MANATEE COUNTY FLORIDA

TO: All Interested Bidders
SUBJECT: Invitation for Bids #14-0667CD
Sludge Holding Tank Improvements at the Southeast
Water Reclamation Facility

ADDENDUM #3

ROBERT J. HALBACH
FLORIDA P.E. # 40139
3-11-14
SHEET M-1

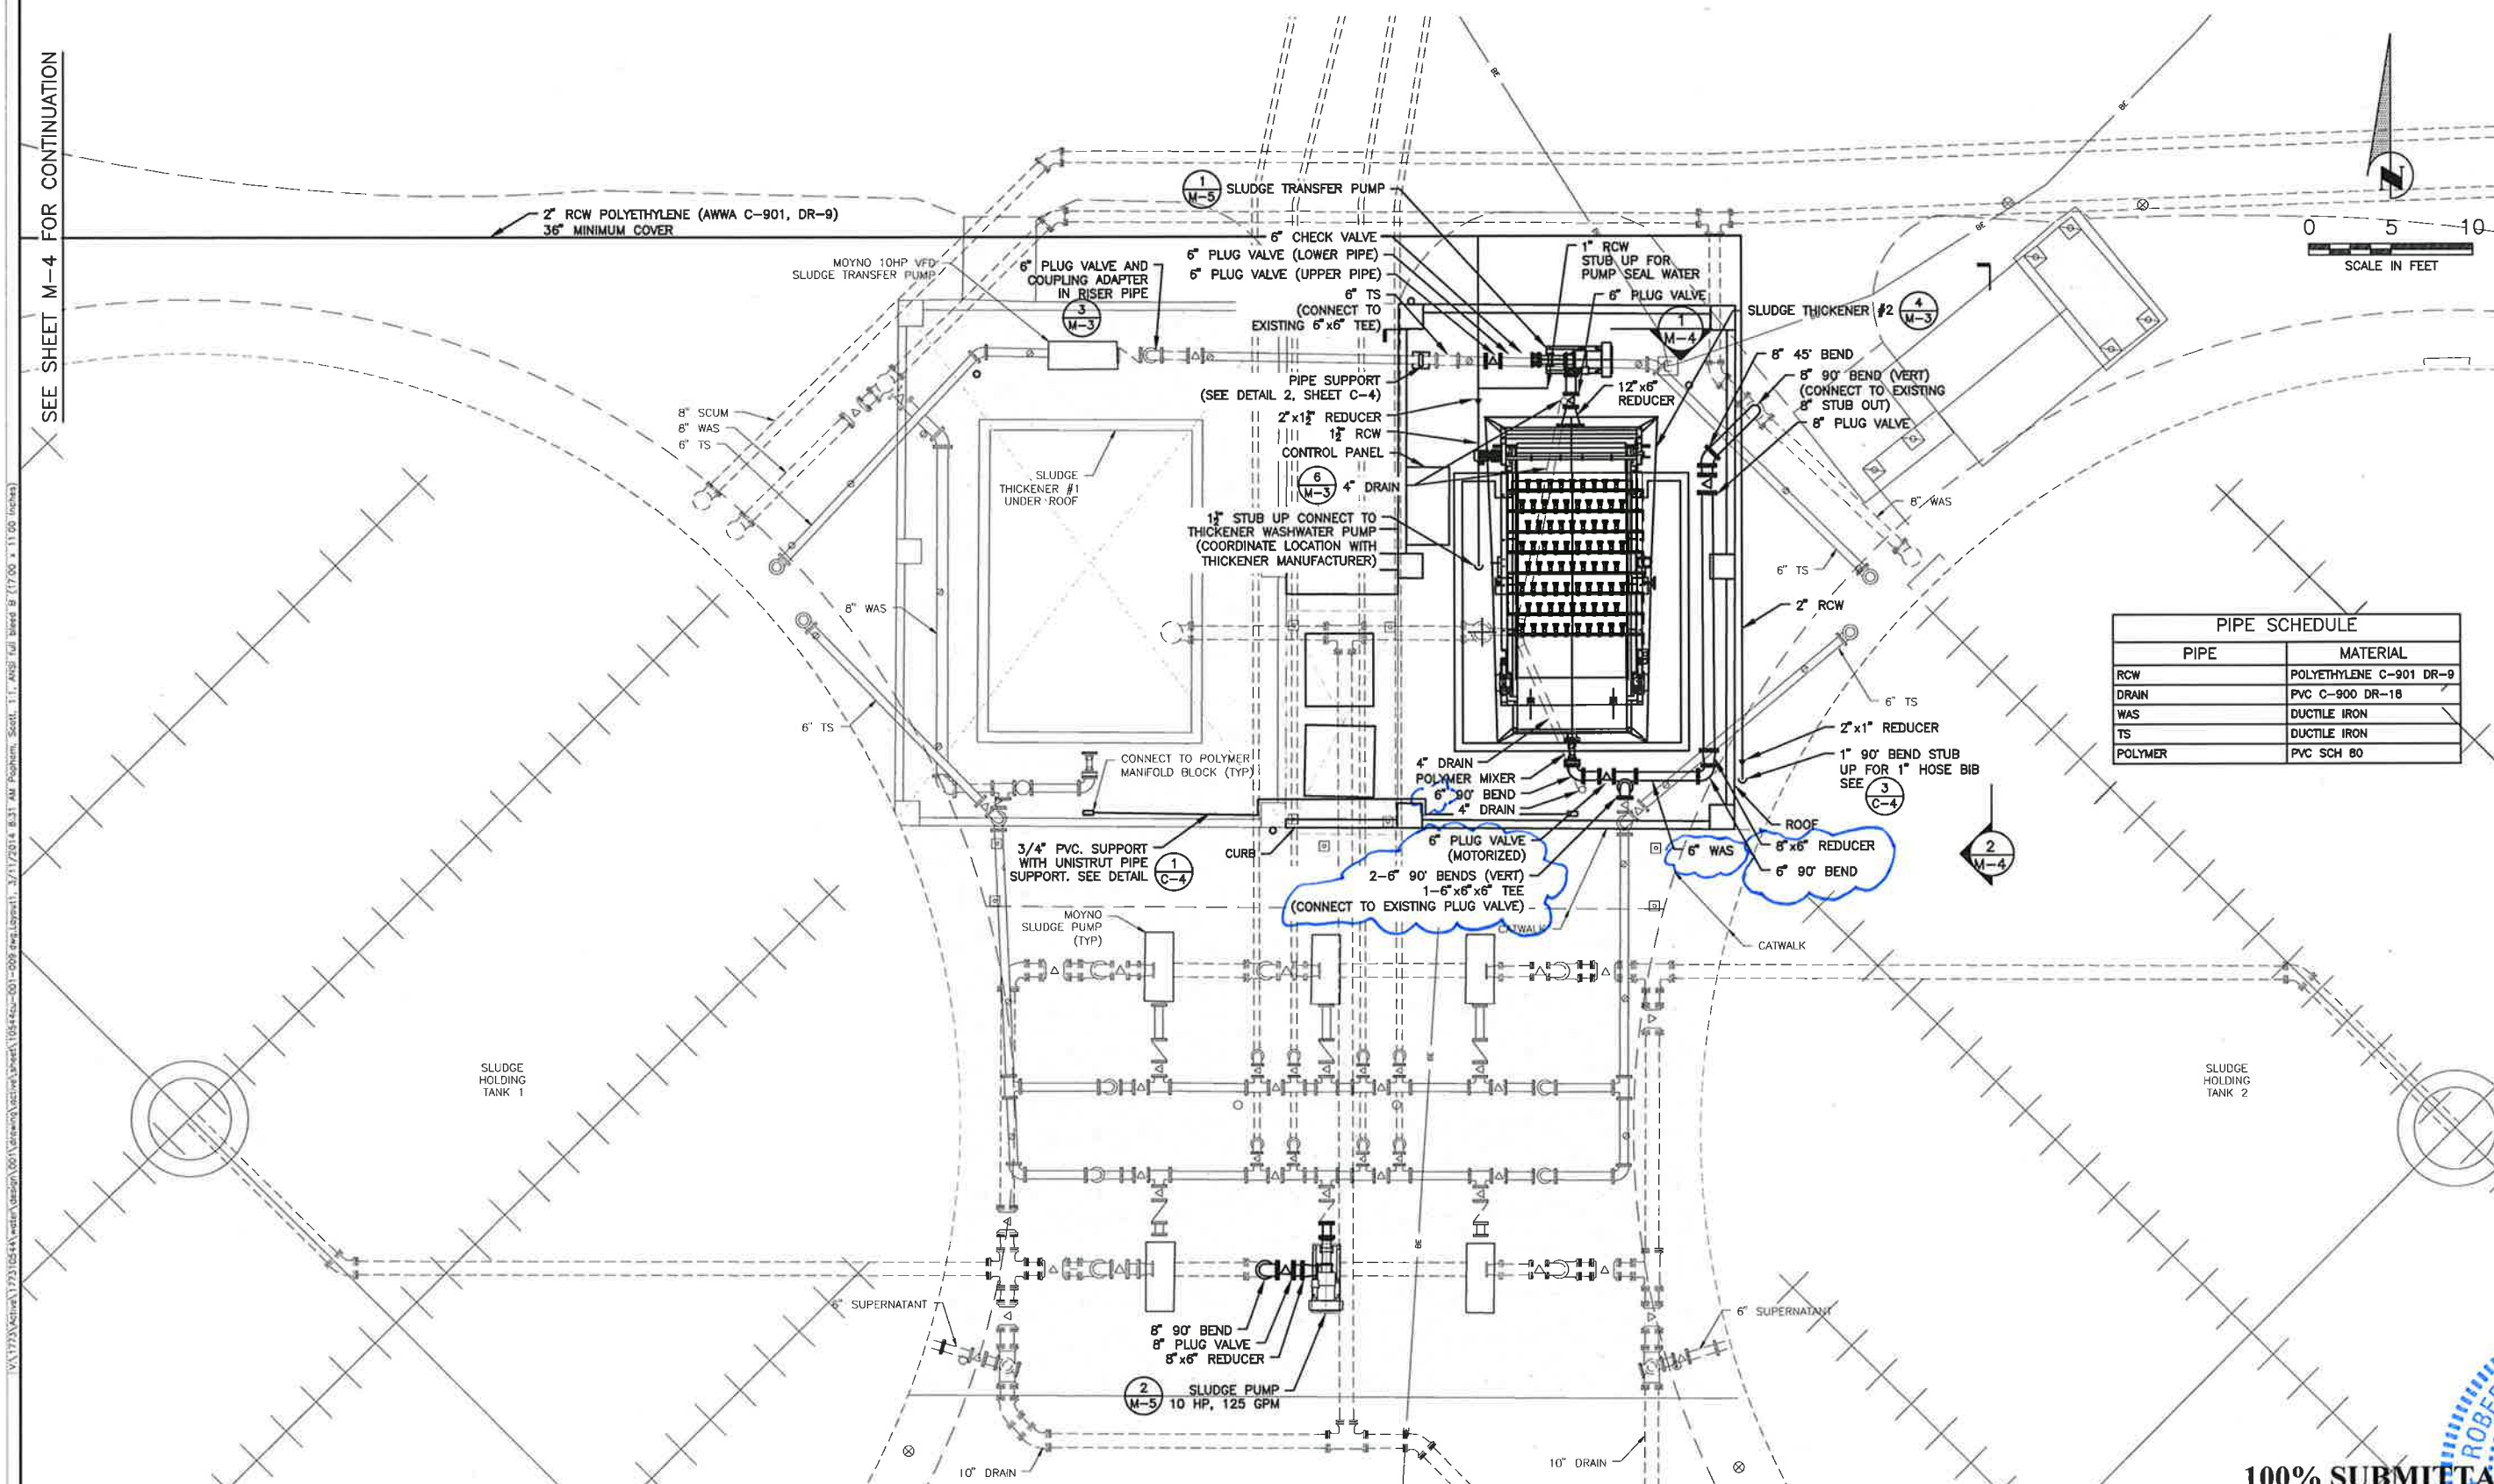
QUESTION #10: Drawings M-1, M-3, and M-4 appear to show an 8" Motor Operated Plug Valve, and 8" Manual Plug Valve, at the Thickener influent line, before the Polymer Mixer. The quantities on the Bid form for Item 5a and 5b, appear to have counted these valves as 6". Please clarify if there is a 6" Motorized Plug Valve, or an 8" Motorized Plug Valve, and if 8" where to include it on the bid form.

QUESTION #11: Drawing M-6, indicates a water source for the 2 new polymer feed units. Drawing M-1 shows a new RCW line to the thickener and pump seal water, but doesn't indicate a new line extending to the polymer units. Please confirm the water source for the new units is existing near the existing unit.

RESPONSE #10: The 6" motorized plug valve is required in this project, see revised sheets M-1 and M-3 attached to this Addendum #3 that clarifies the pipe, fittings and valve sizes.

RESPONSE #11: The existing water service will feed the polymer units.

2 SUMP AND 10" DIP SLUDGE SUCTION (BY OTHERS) 1/2"=1'0"

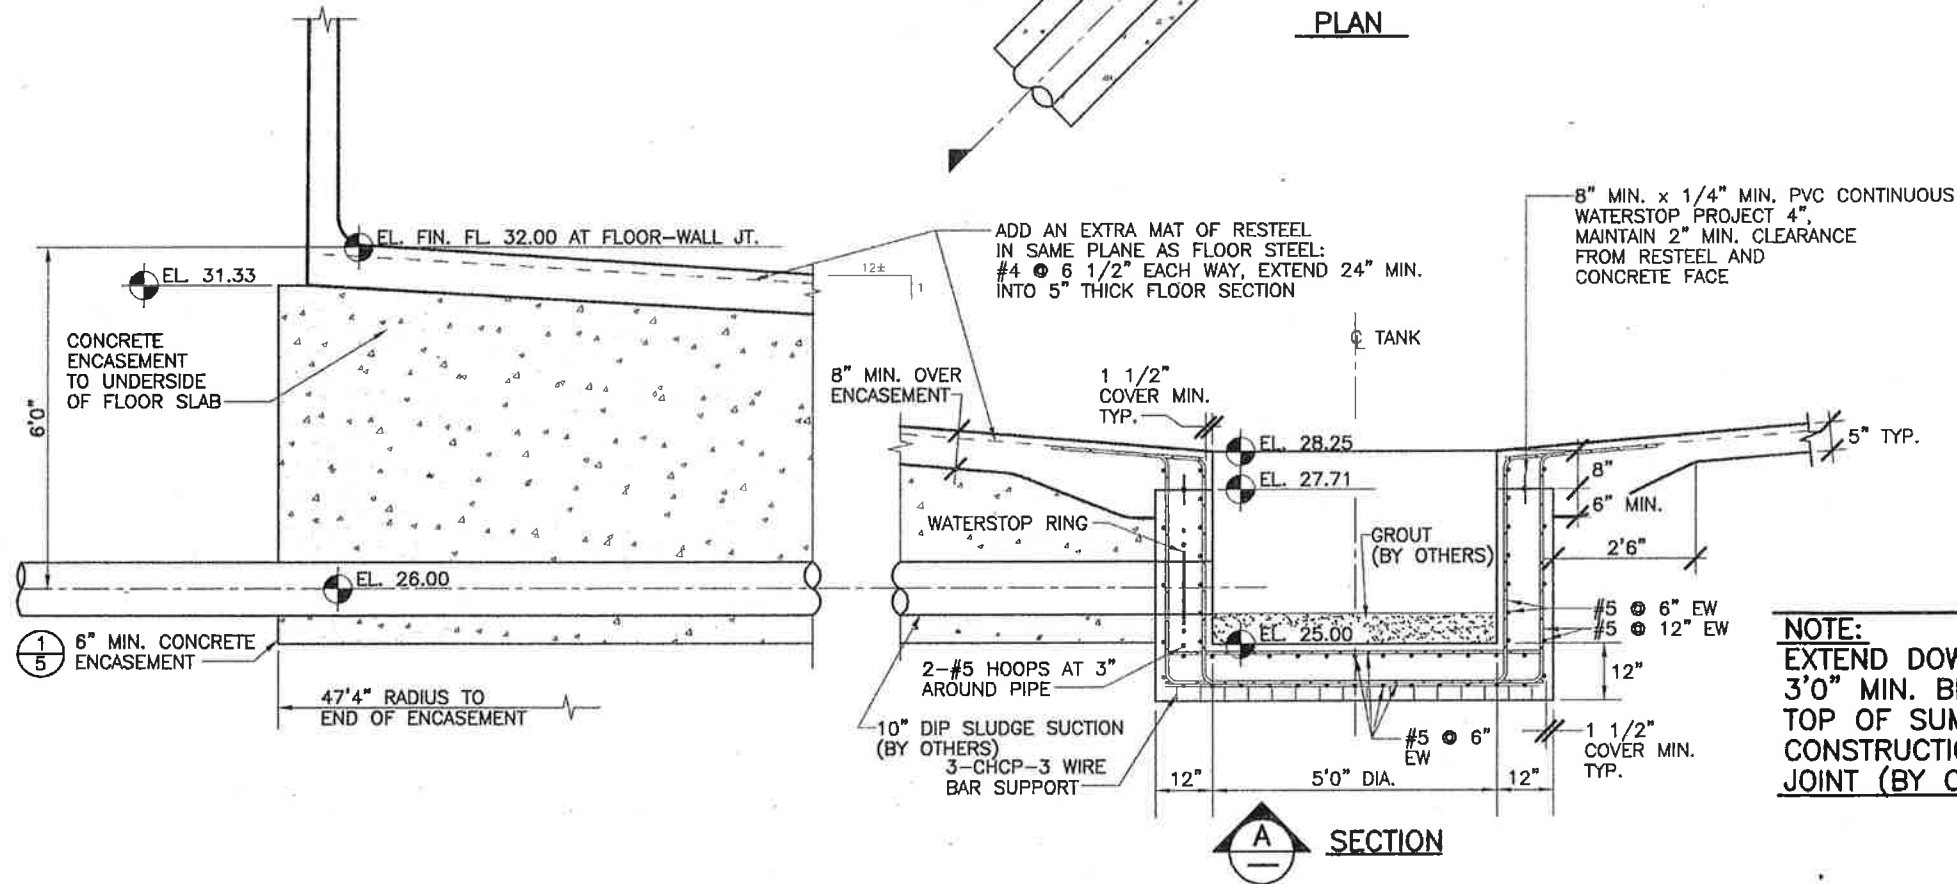
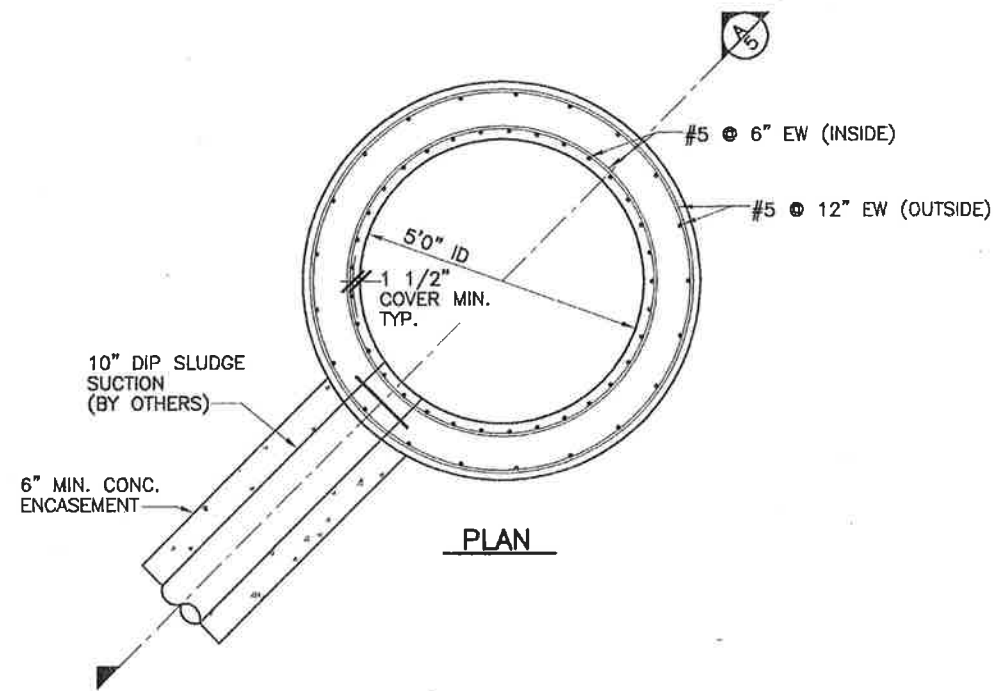
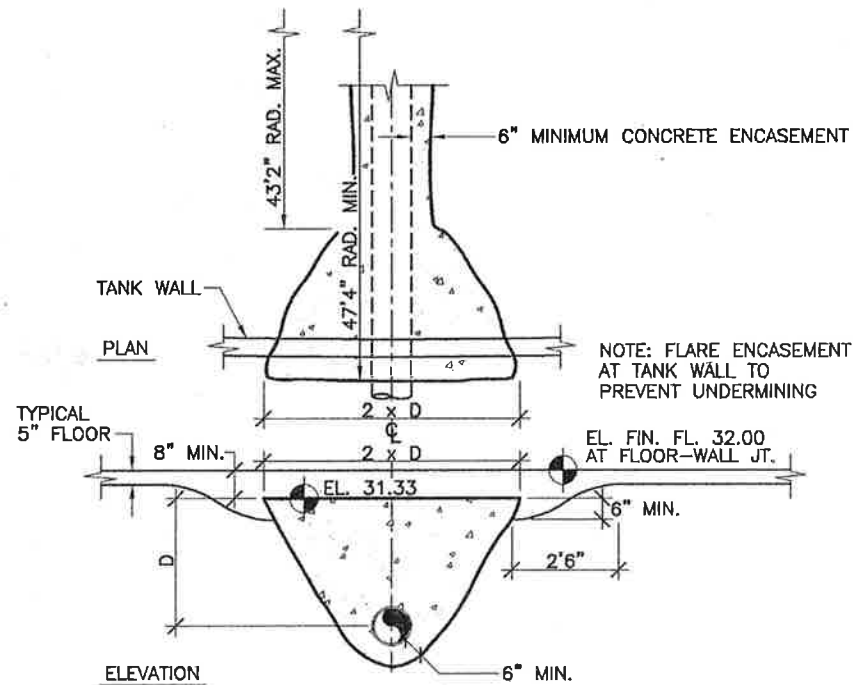
QUESTION #2: Do you have details on the tank drain system for sludge holding tanks #1 & #2? If so would you provide those? Is there a floor drain in the tank or is the only way to drain the tank by using the sludge pumps?

RESPONSE #2: See the record drawings for the floor drain details that are attached to this Addendum #3.
